MX8ULP-EVK9SOM (52006)

MX8ULP-EVK9SOM Board Errata

Rev. 0.1 -- 18/Aug/2023

E-001: SPI FLASH U14 doesn't work.

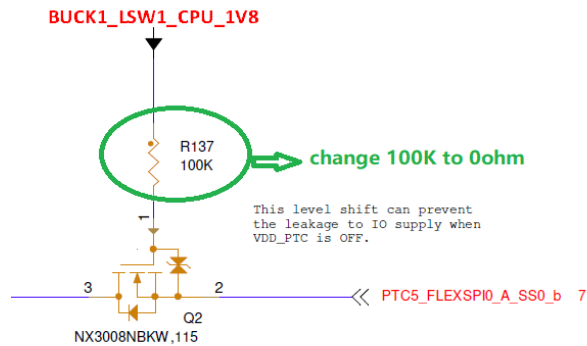
SPI FLASH access failed

It is caused by the high value(100K) of R137

SPI FLASH U14 doesn't work in rev B boards

Replace R137 with 0ohm/0402 resistor

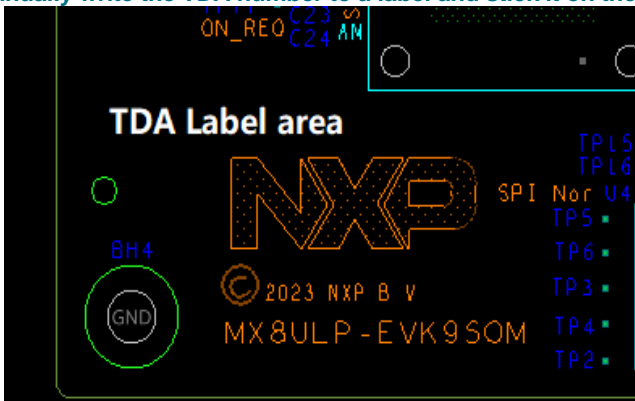
5. On bottom side of DUT, mount R137 with a 0ohm/0402 resistor

1. Prepare a 0ohm/0402 resistor
2. Before to do rework, please follow step 1~5 in section "Test the rework" to verify board can enter uboot normally. If yes, continue below steps:
3. Make sure remove the power adapter and USB cable from board.
4. Pull out the DUT board from BB board softly as the red square show
